1 **1. Site Information**

1 **2. Operations And Safety FortisBC Submission to the BCUC 15-03-07**  
2 **Reference Page 3**  
3 **Comparing the Penticton Abbot Street Substation (fenced area 125 x 125ft) with two**  
4 **existing transformers to the Fire Hall site (possible fenced area 149 x164ft)\* with**  
5 **one proposed transformer.**

DIVISION	OKANAGAN
DEPARTMENT	TRANSMISSION-DISTRIBUTION
LOCATION	ARAWANA SUBSTATION - OPTION 1
TITLE	EXISTING STATION CROSS-SECTIONS

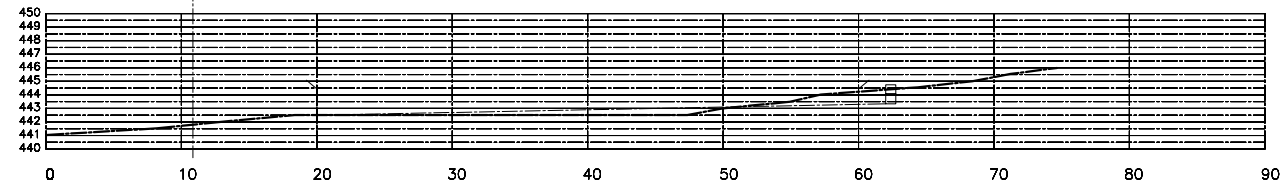
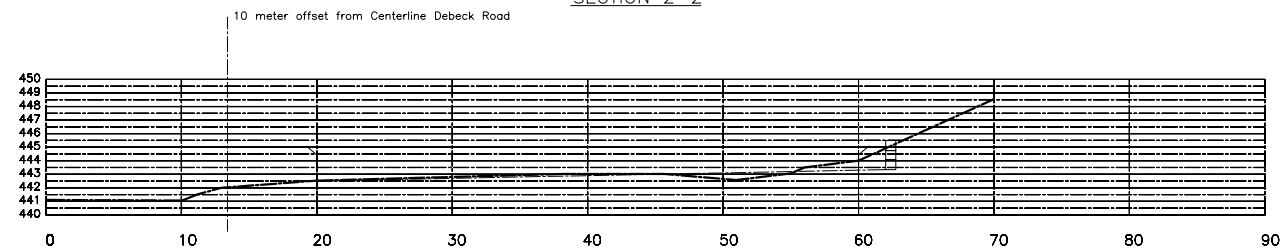
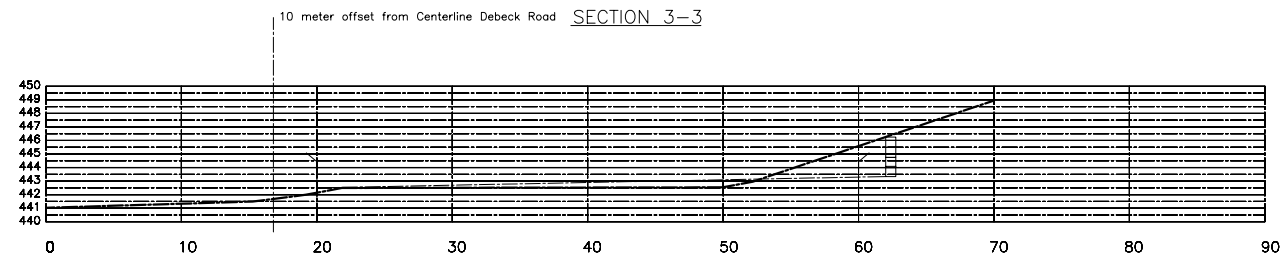
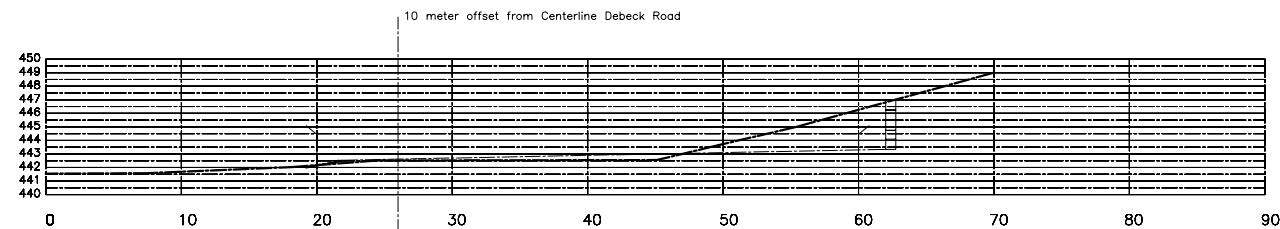
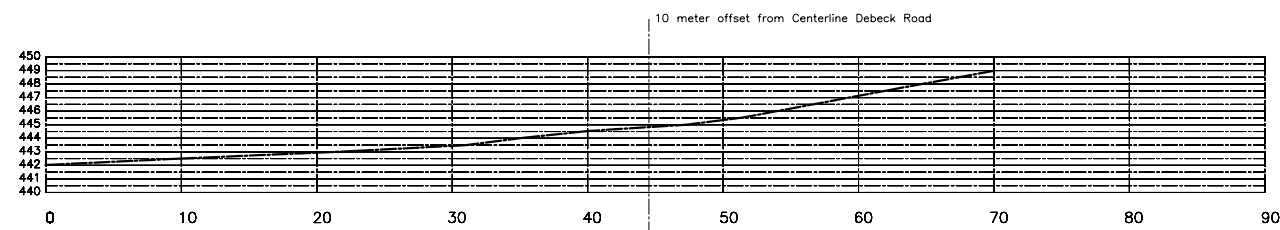
12  
13 **Q1.3 To what length, width, and depth will the earth on the north side of the Fire Hall**  
14 **site have to be excavated?**

15 A1.3 The exact dimensions would be determined during detailed design and would be  
16 dependent on final siting of the substation on a site. Cross sections are provided as  
17 Appendix A1.3.
